**SUSQUEHANNA STEAM ELECTRIC STATION
REQUEST FOR ADDITIONAL INFORMATION (RAI) FOR THE
REVIEW OF THE SUSQUEHANNA STEAM ELECTRIC STATION
UNITS 1 AND 2, LICENSE RENEWAL APPLICATION (LRA)
SECTIONS 2.2, 2.3.3, 2.3.4
PLA-6276**

**Docket Nos. 50-387
and 50-388**

Enclosure: PPL Responses to Request for Additional Information (Sections 2.2, 2.3.3, 2.3.4)

LR-M-153-2

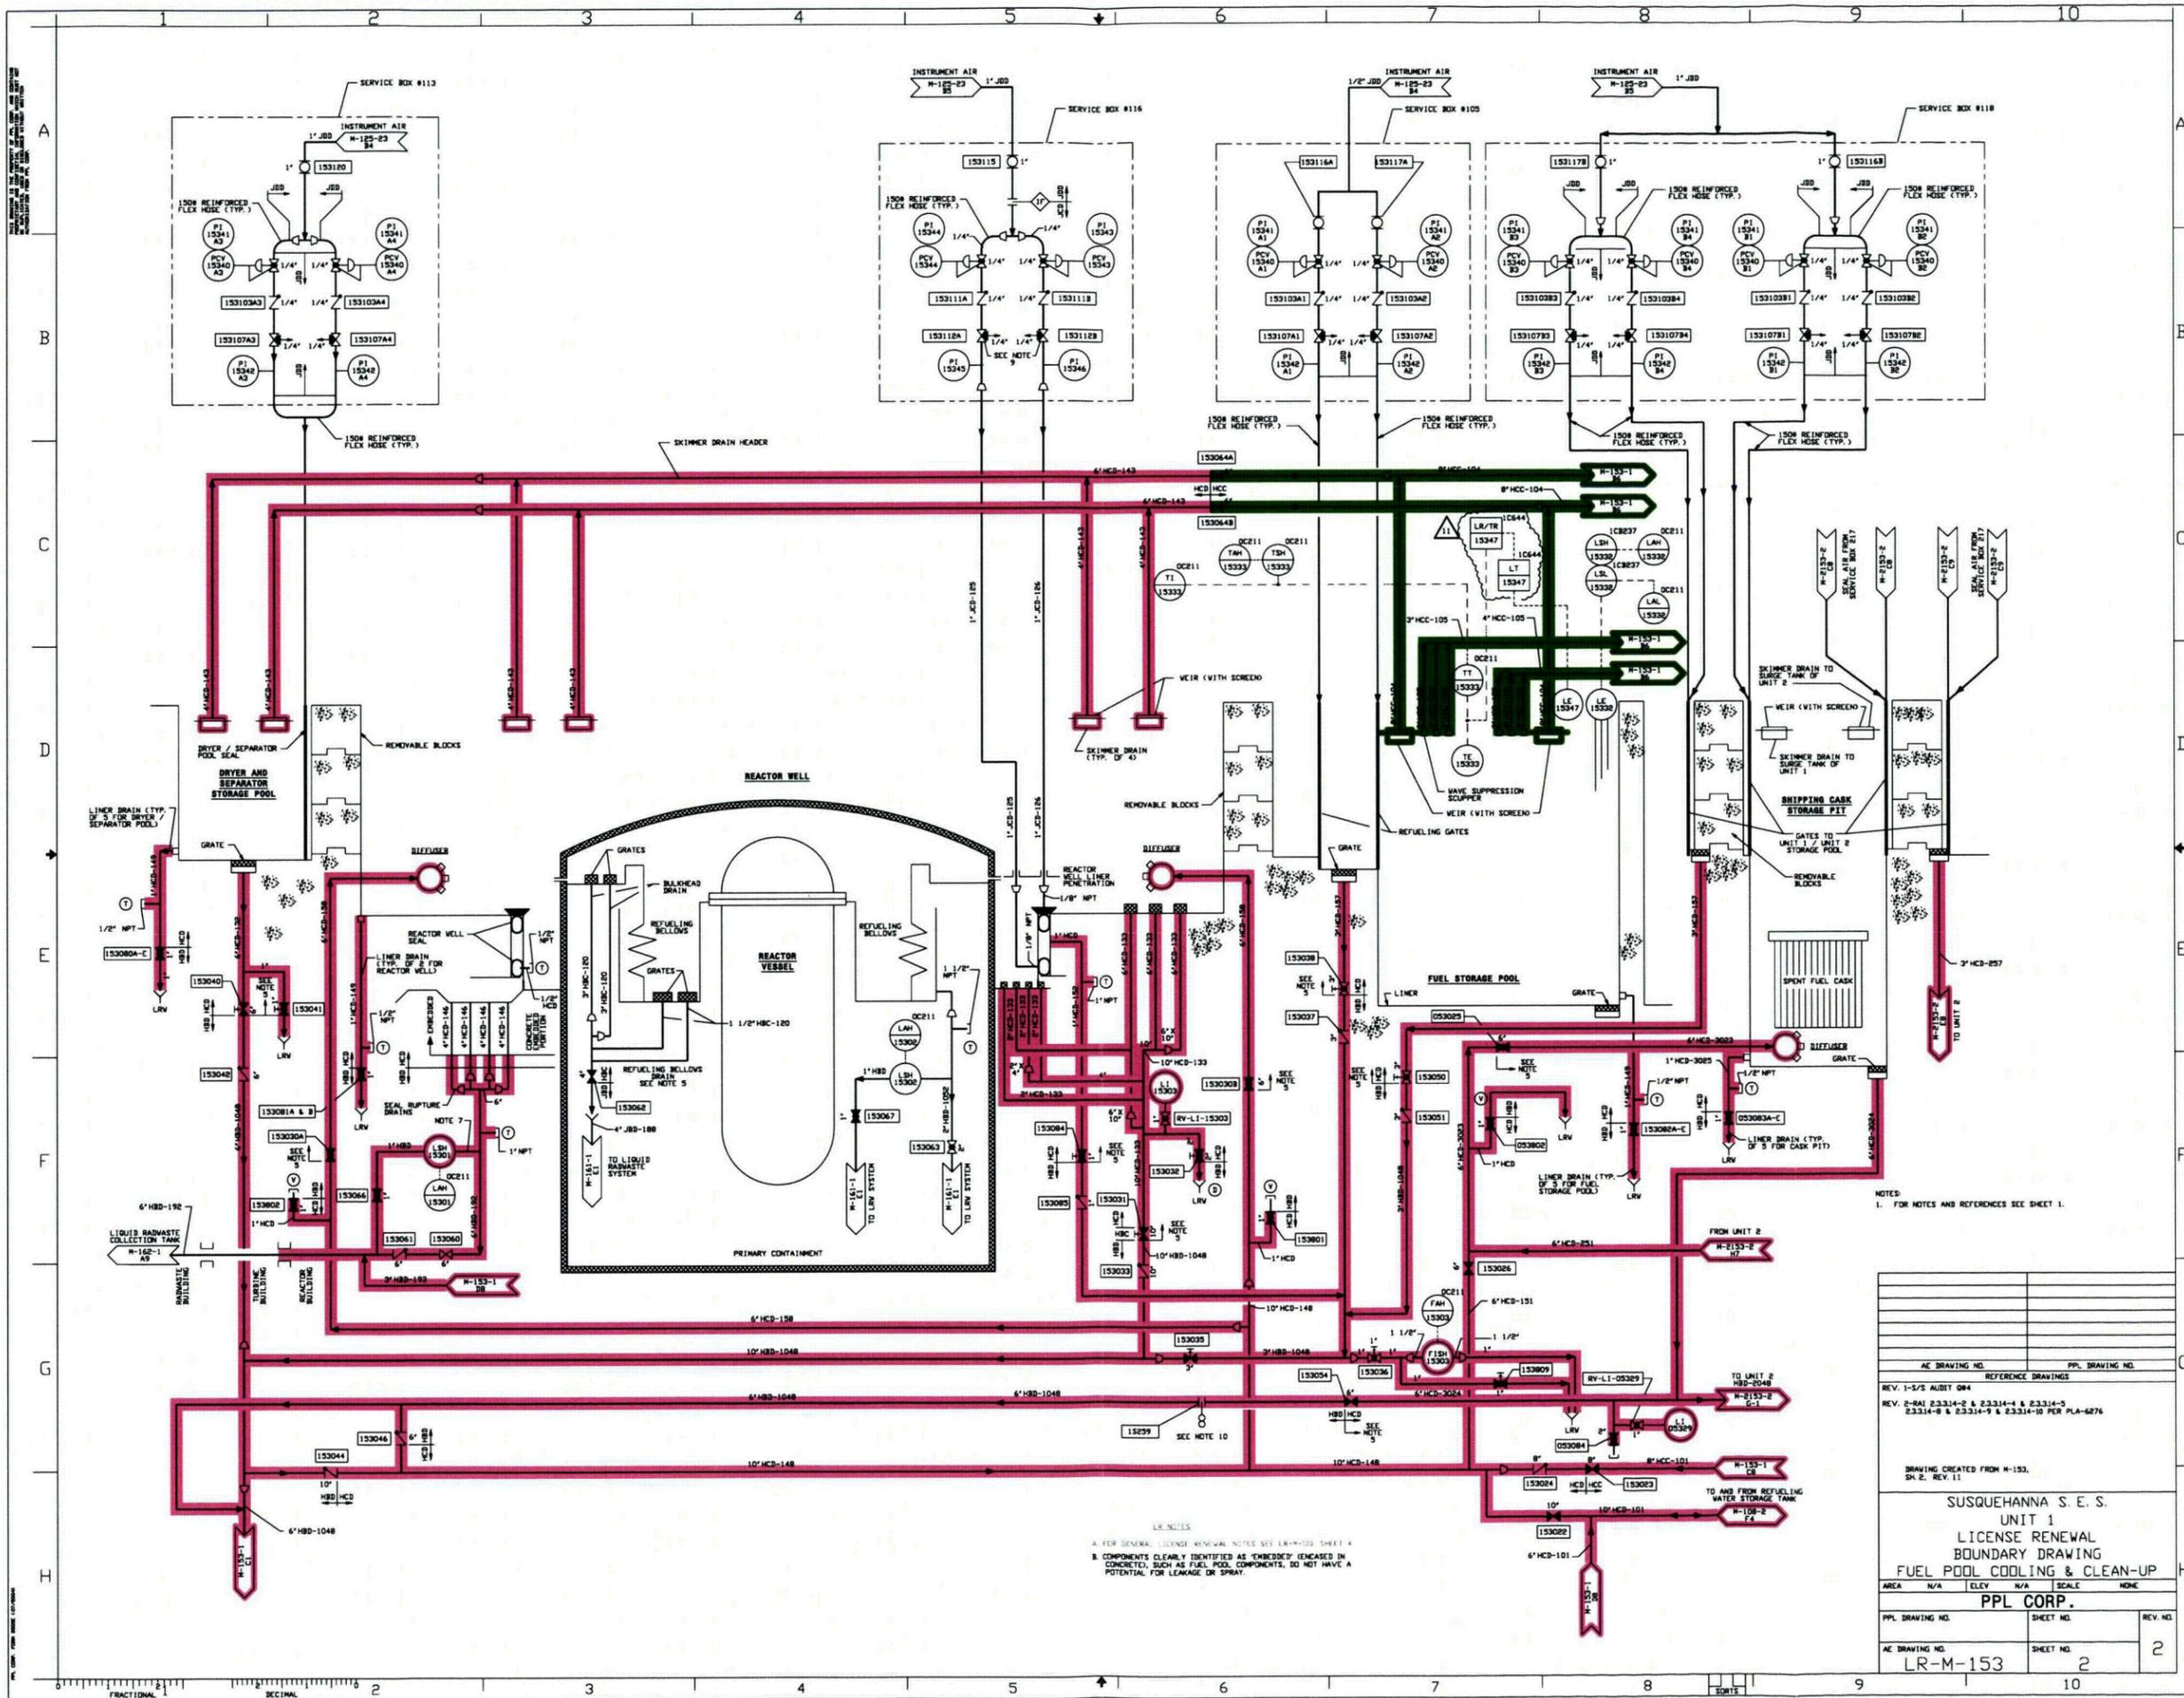
License renewal drawing LR-M-153-2, location G8, shows within the scope of license renewal a continuation of six-inch HCD-3024 piping to drawing LR-M-2153 without the drawing sheet number and location provided. The review of drawing LR-M-2153 showed a continuation of the six-inch HCD-3024 piping on drawing LR-M-2153-2 at location G1. Provide additional information to establish the correct continuation drawing, sheet number, and location on drawing LR-M-153-2.

There is a typographical error on LR-M-153-2, which will be revised as follows: The continuation arrow at location G8, "TO UNIT 2 HBD-2048", now reads "LR-M-2153-2 G1" instead of "LR-M-2153."

DRAWING	CONDITION	CHANGE
LR-M-153-2	The continuation arrow for the six-inch HCD-3024 piping at location G8 indicates that the line is continued on drawing LR-M-2153 with no sheet or location indicated.	Revise the continuation arrow for the one-inch HCD-3024 piping, at location G8, to indicate that the piping is continued on drawing LR-M-2153-2 at location G1.

LR-M-154-1

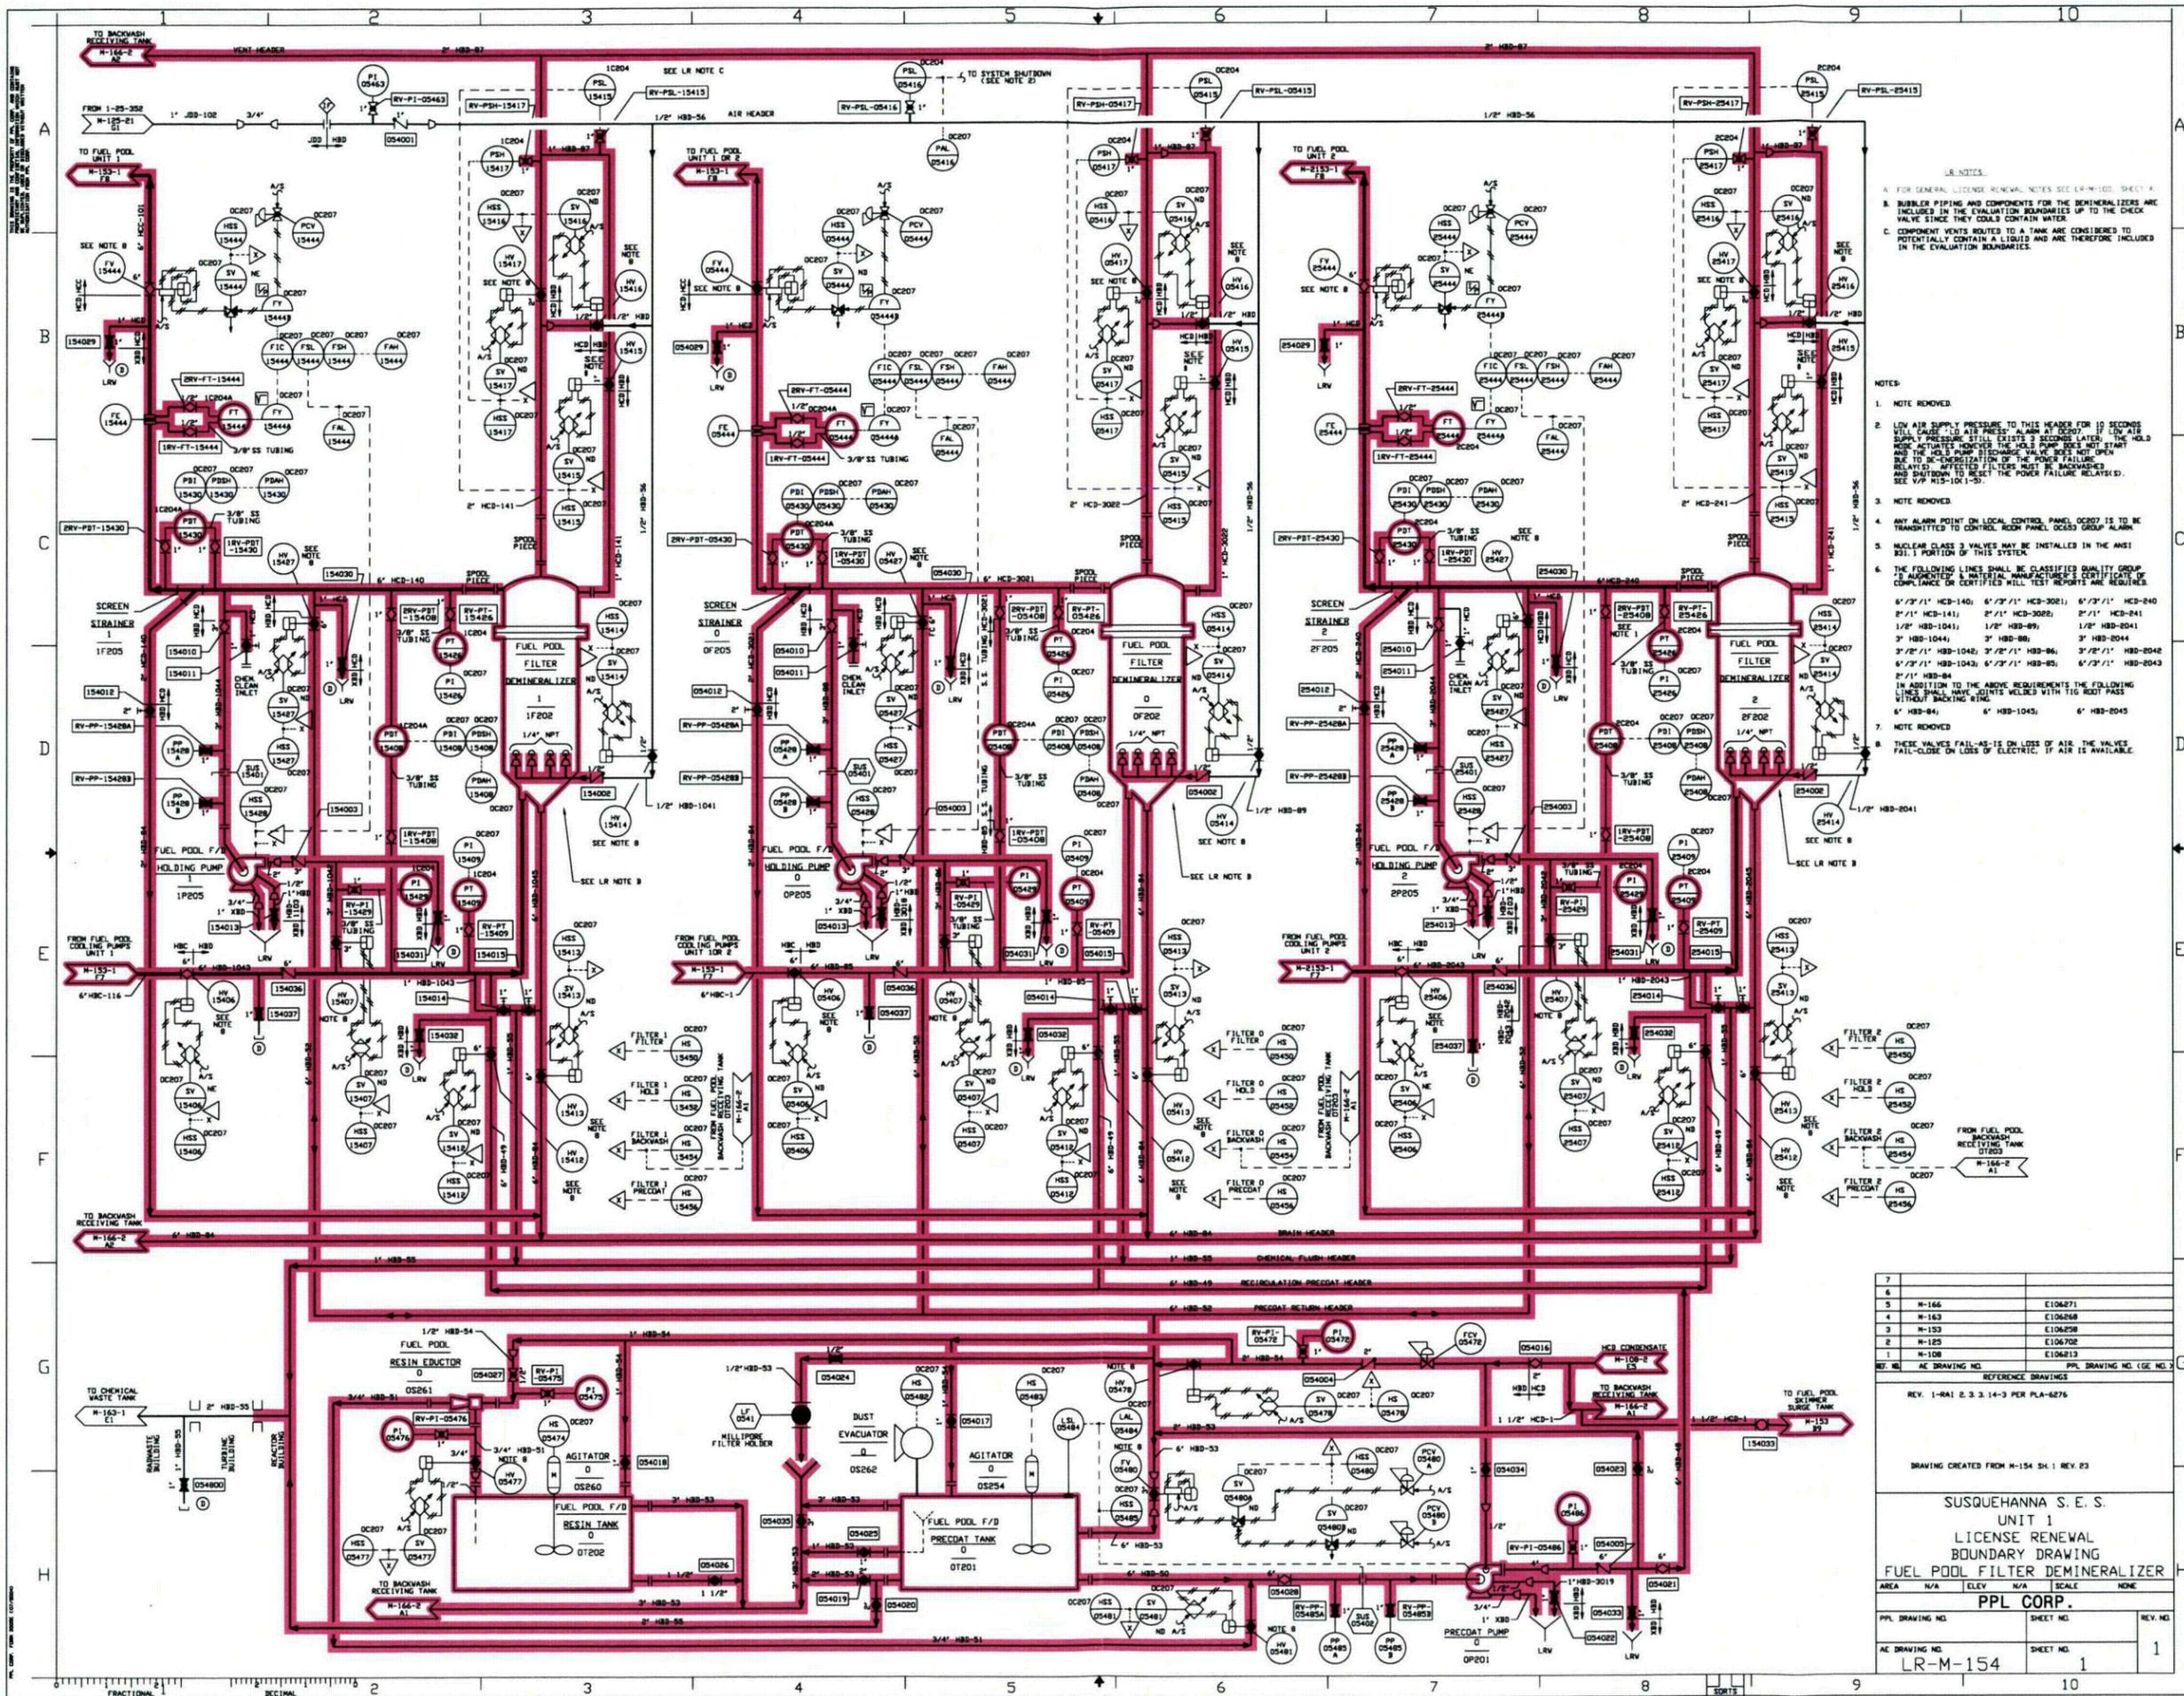
License renewal drawing LR-M-154-1, locations C3, C6, and C9, shows the boundary (based on 10 CFR 54.4(a)(2)) at the top of the fuel pool filter demineralizers. Though not within scope, two-inch vent pipes are shown that exit the top of the filter demineralizers and go to the vent header two-inch HBD-87 piping, which also is not within scope. License renewal drawing LR-M-154-1, location A1, shows a continuation from the out-of-scope vent header two-inch HBD-87 piping to drawing LR-M-166-2, location A2, where the two-inch HBD-87 piping is shown within the scope of license renewal. Provide additional information explaining why the two-inch vent piping and two-inch HBD-87 vent header piping are not within the scope of license renewal and justify the boundary locations with respect to the applicable requirements of 10 CFR 54.4(a).

The vent piping from the fuel pool filter demineralizers on drawing LR-M-154-1 up to the vent header and continuing onto drawing LR-M-166-2 at location A2 and to the connection to the fuel pool backwash receiving tank is within the scope of license renewal per the criteria of 10 CFR 54.4(a)(2). The drawings are revised to highlight the piping as pink (magenta).
